Modification Recommended Service Note

N8943A - Autoranging System DC Power Supply, 500V, 30A, 5000W, 400 VAC

Serial Numbers: DE14290000 - DE15369999 without manufacturing ID Version "B"

5) SMT resistors R93/94 are located in red circle shown below:

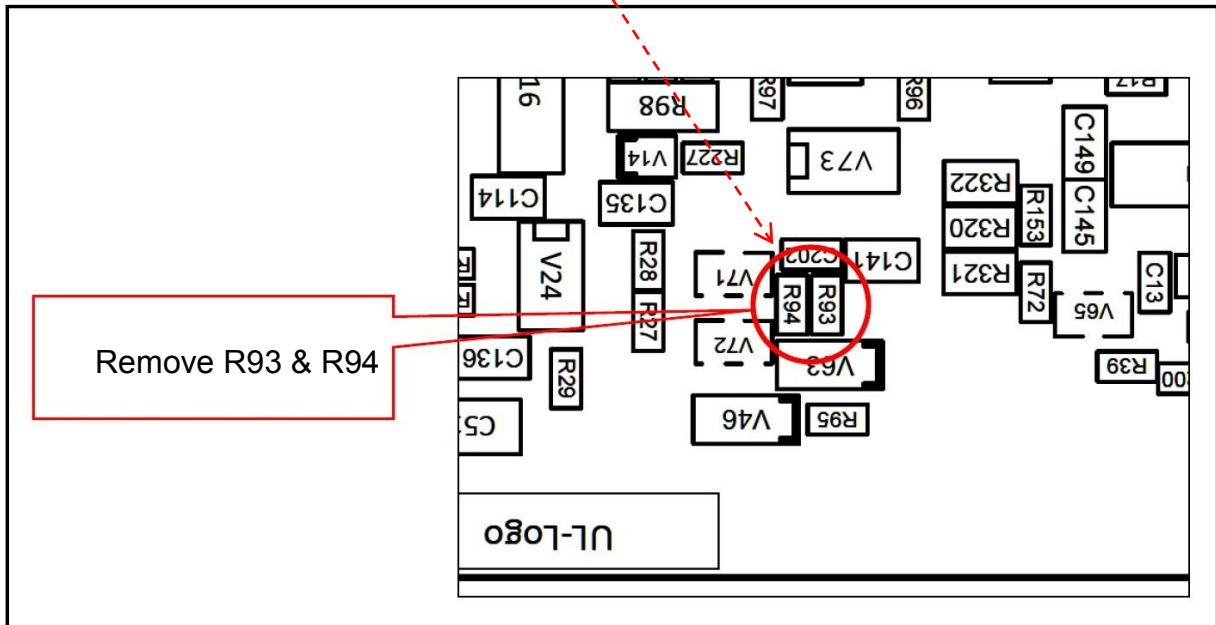
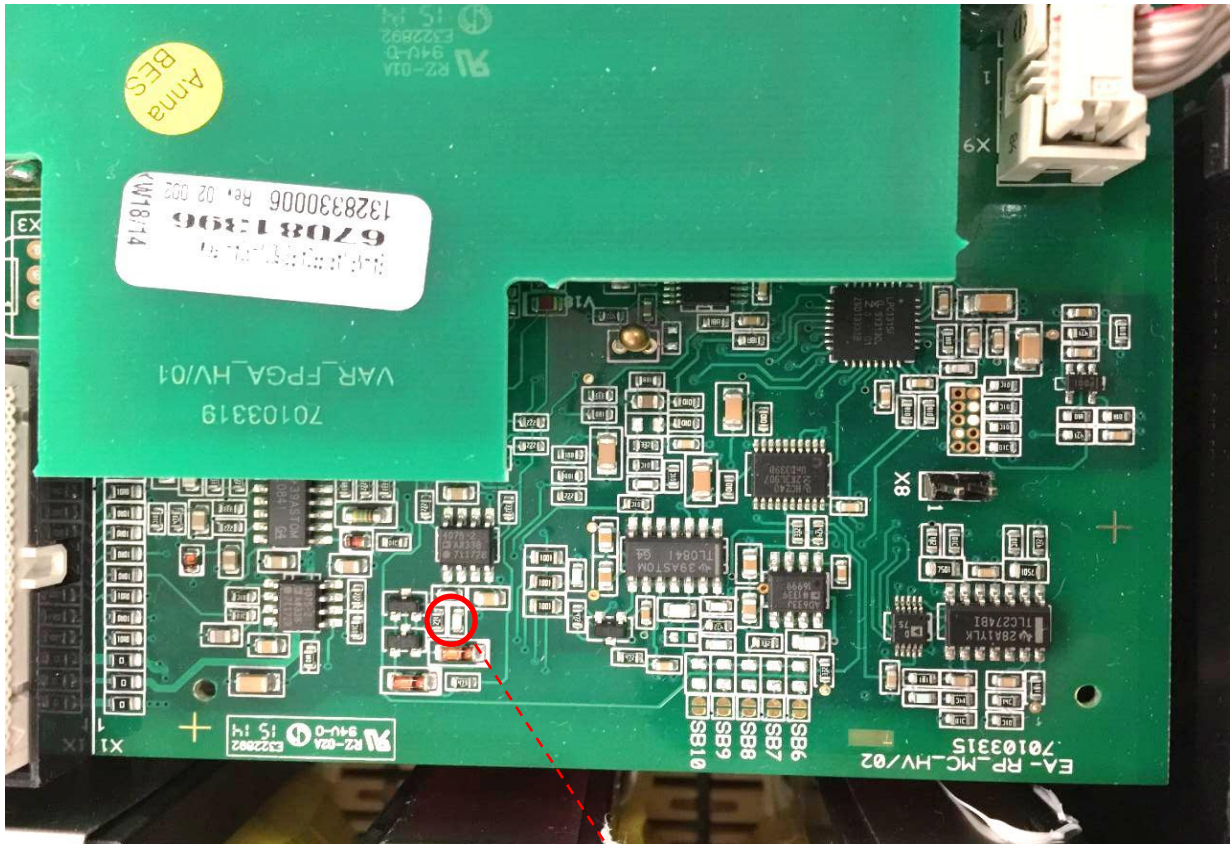
Removal of two (2) surface mount resistors, R93 and R94, will correct this problem:

6) After removal of R93 & R94, re-install all covers. Instrument does NOT require recalibration after the removal of R93 & R94.

Suffix “B” added

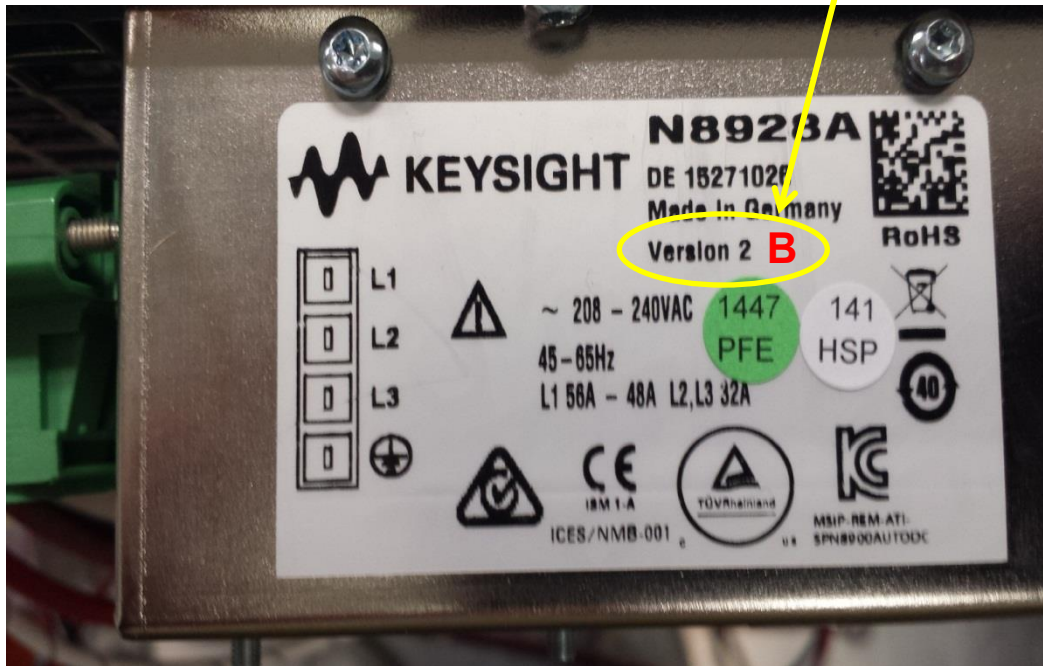
7) On the acMains label, on the rear of the instrument; use an indelible marker, to add the suffix letter “B” after the Version ID. This will assist in the tracking of modified instruments.
